SUBJECT: Donald C. Cook Nuclear Plant Units 1 and 2
Docket Nos. 50-315 and 50-316
License Amendment Request to Modify Allowable Storage Patterns in Spent Fuel
Storage Racks

Proposed License Amendment to Modify Allowable Storage Patterns in Four Spent Fuel Storage Modules

DONALD C. COOK NUCLEAR PLANT UNIT 1 TECHNICAL SPECIFICATION PAGES
MARKED TO SHOW CHANGES

**DONALD C. COOK NUCLEAR PLANT UNIT 2 TECHNICAL SPECIFICATION PAGES
MARKED TO SHOW CHANGES**

Figure 4.3-1 (page 1 of 1)
Normal Storage Pattern (Mixed Three Zone)

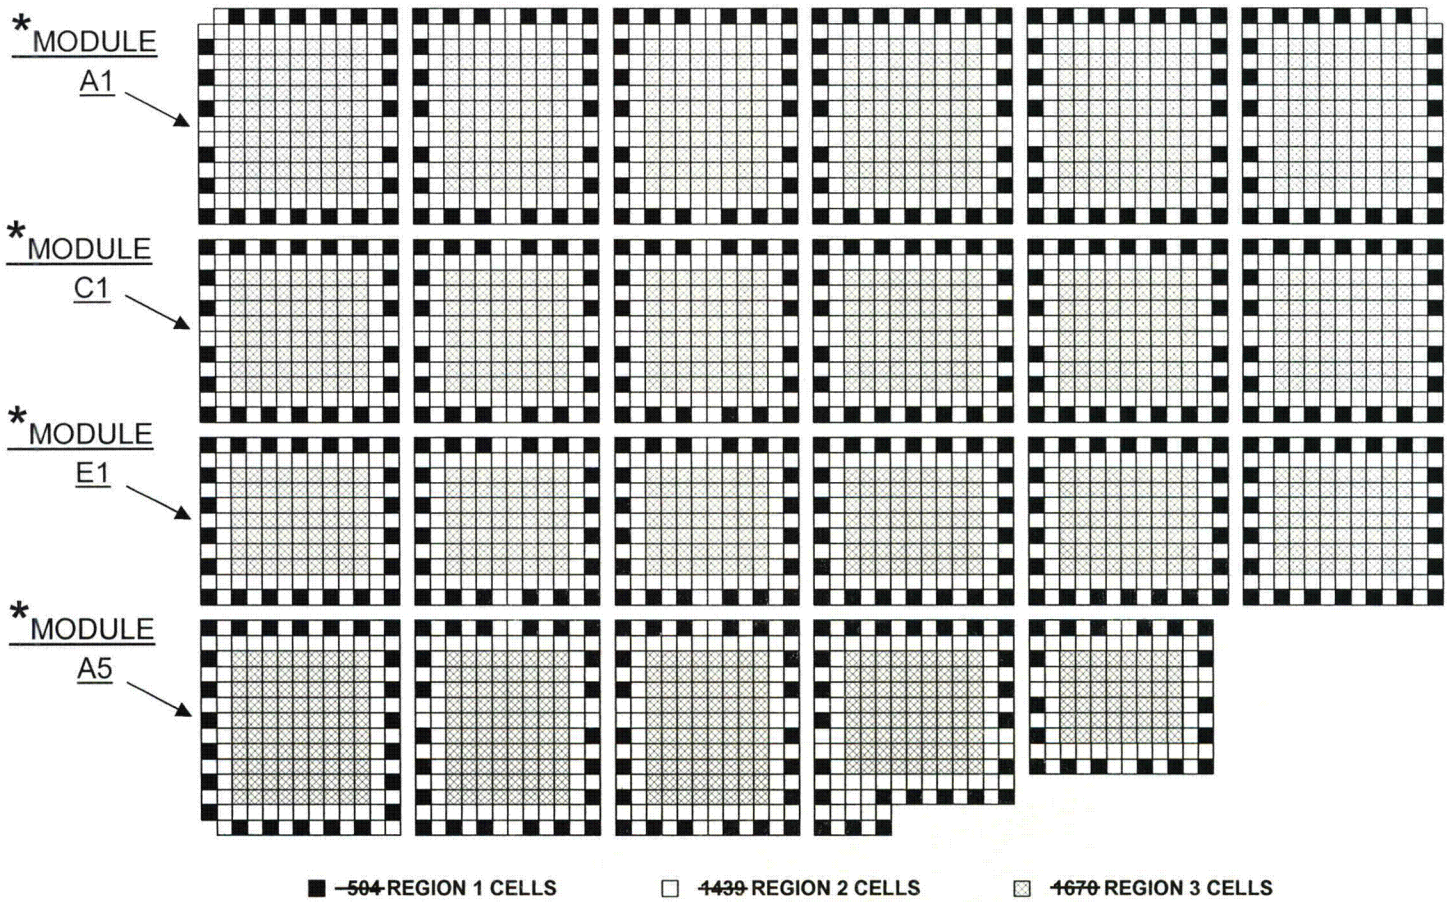
- Add the alpha-numeric designations A1, C1, E1, and A5, to the four fuel modules that comprise the vertical row on the left side of the figure.
- Add a note indicating that the storage pattern for any of these individual modules, A1, C1, E1, or A5, may be in accordance with Figure 4.3-1 or Figure 4.3-2.
- Delete the value for the total number of cells in each of the three storage regions (Region 1, Region 2, and Region 3), and on Figure 4.3-2 only, delete the value for the total number of cells that are to be left empty.

The alpha-numeric designations were added to differentiate the modules involved in the proposed change (those on the left side of the figure) from the remainder of the modules. The alpha-numeric designation for each of the four modules corresponds to that shown in Figure 2.1.1 of Reference 1 and Figure 9.7-2 of the UFSAR.

The notes were added to accomplish the fundamental objective of the proposed amendment, i.e., to allow any of the specified modules to be loaded in accordance with either the normal pattern (Figure 4.3-1) or the interim checkerboard pattern (Figure 4.3-2).

The values for the total number of cells in each category were deleted because the values can change depending on the loading pattern used for each of the individual modules A1, C1, E1, and A5. The analyses discussed in the Holtec technical evaluation provided as Enclosure 3 to this letter demonstrate that compliance with the storage patterns specified in TS Figure 4.3-1 and Figure 4.3-2 in accordance with this proposed amendment will assure safety. Therefore, the specific values for the total number of cells in each category are not important to safety, and the inclusion of these values in TS is not required by 10 CFR 50.36(d)(4).

* The storage pattern for any of these individual modules may be as shown in this figure or Figure 4.3-2.

Figure 4.3-2 (page 1 of 1)
Interim Storage Pattern (Checkerboard)

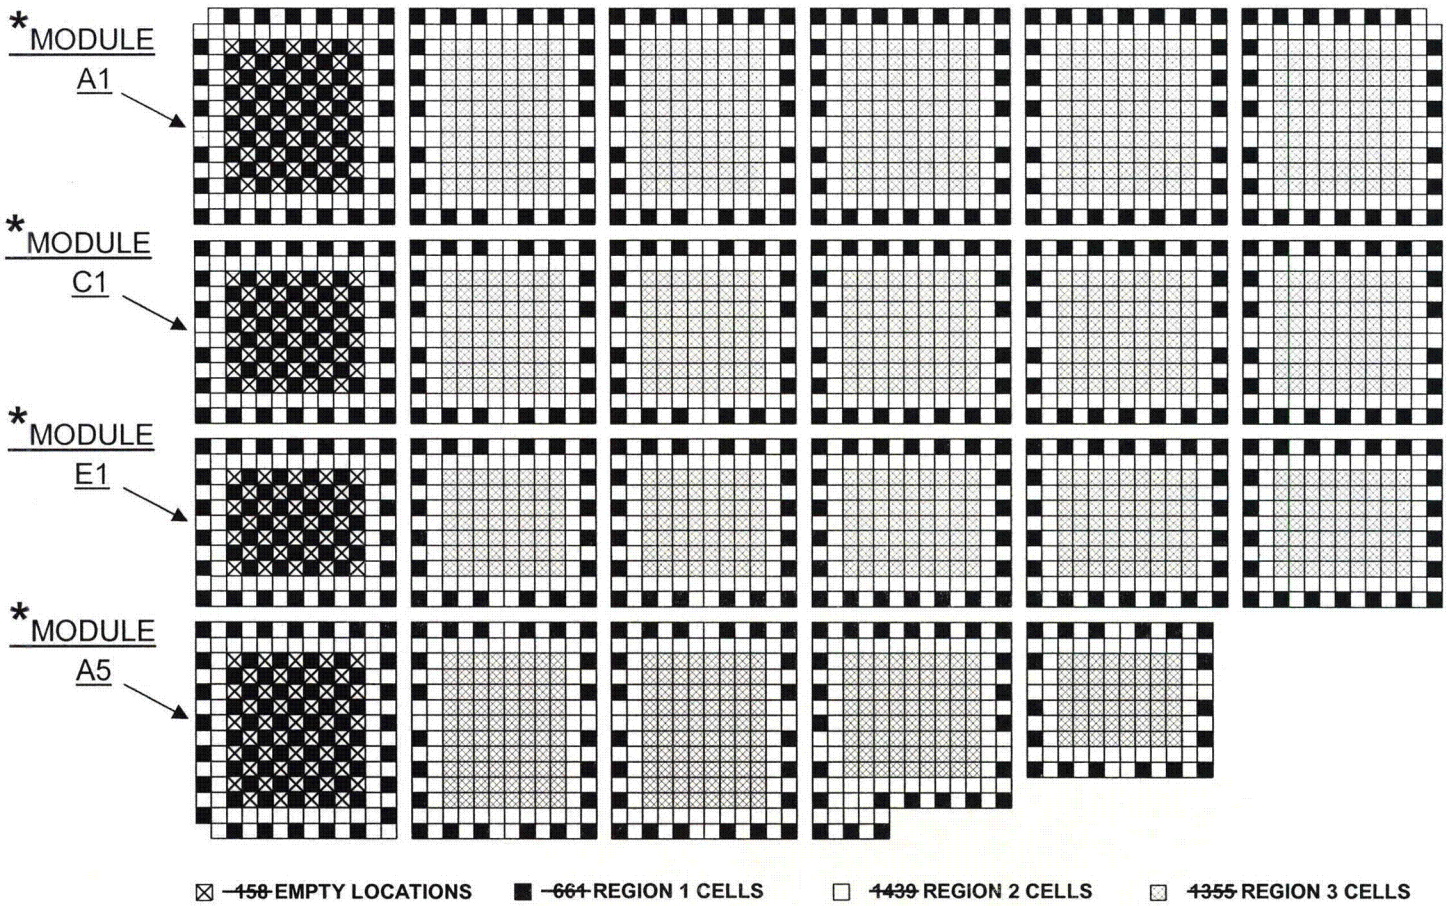
* The storage pattern for any of these individual modules may be as shown in this figure or Figure 4.3-1.

Figure 4.3-1 (page 1 of 1)
Normal Storage Pattern (Mixed Three Zone)

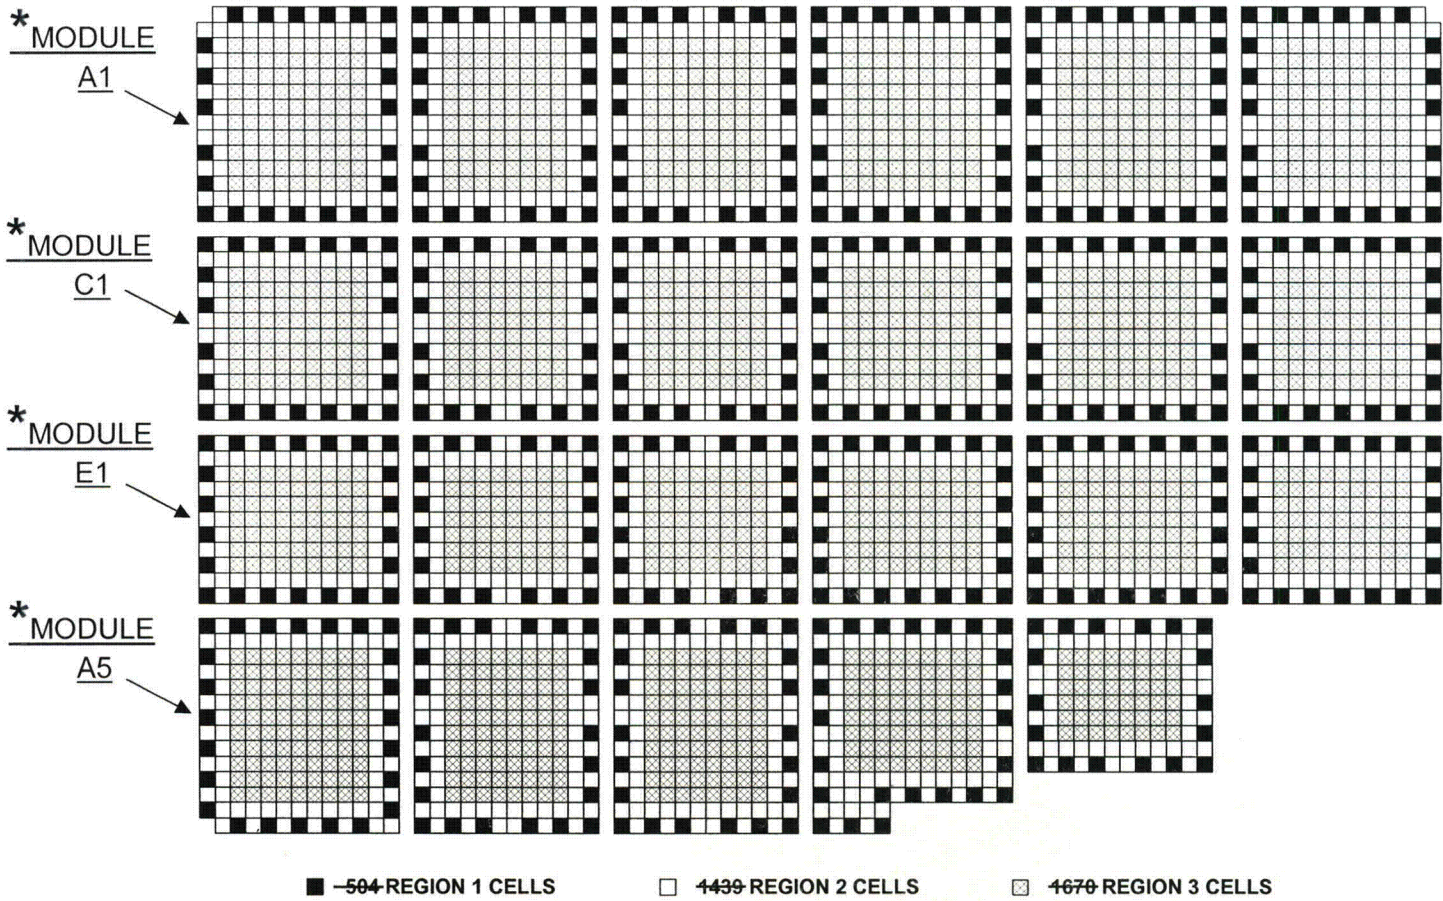
* The storage pattern for any of these individual modules may be as shown in this figure or Figure 4.3-2.

Figure 4.3-2 (page 1 of 1)
Interim Storage Pattern (Checkerboard)

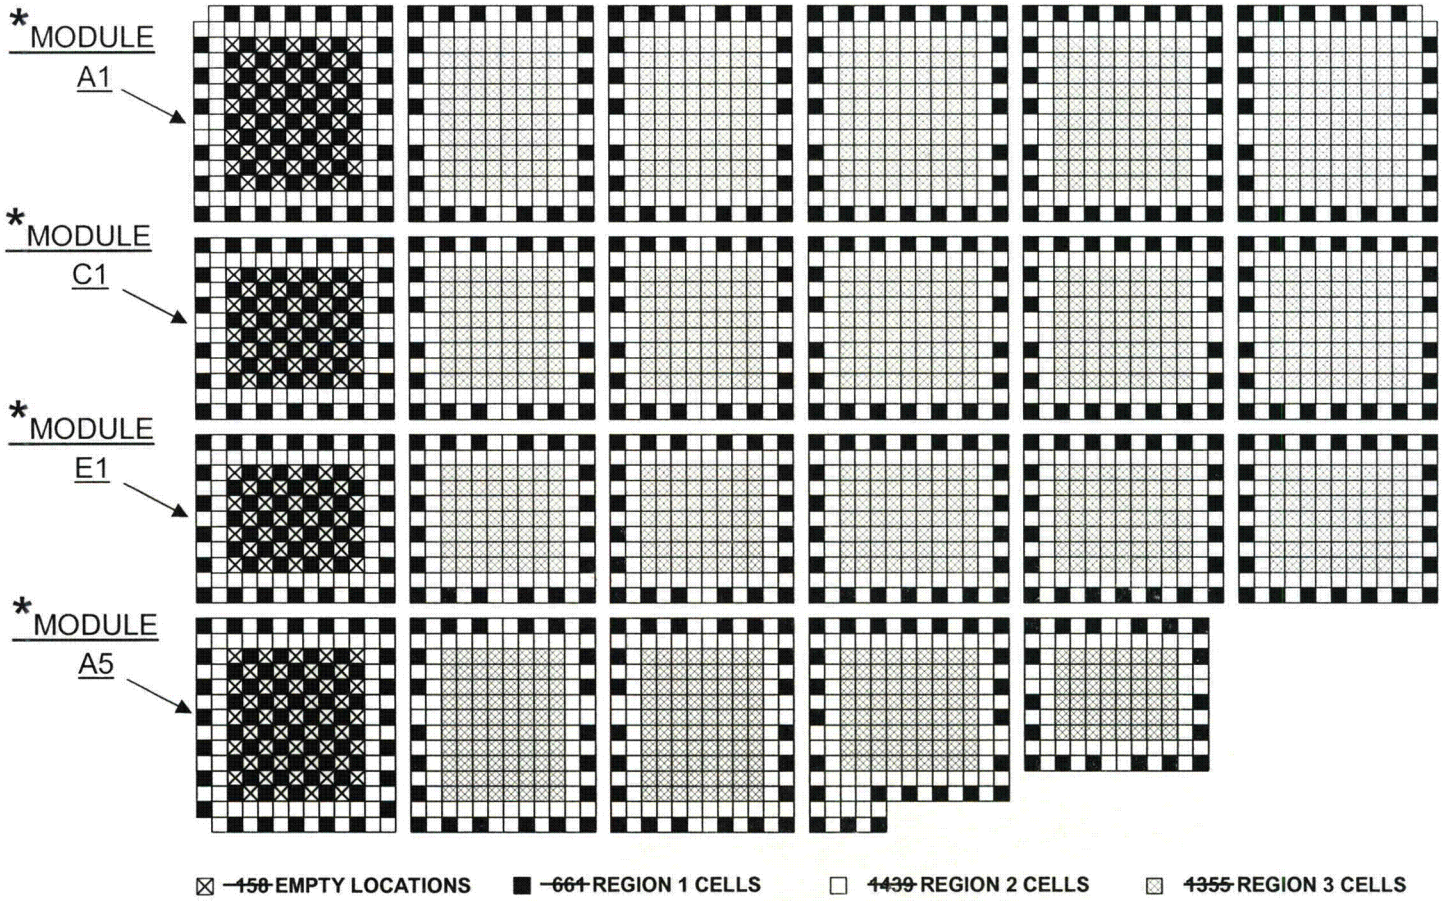
* The storage pattern for any of these individual modules may be as shown in this figure or Figure 4.3-1.
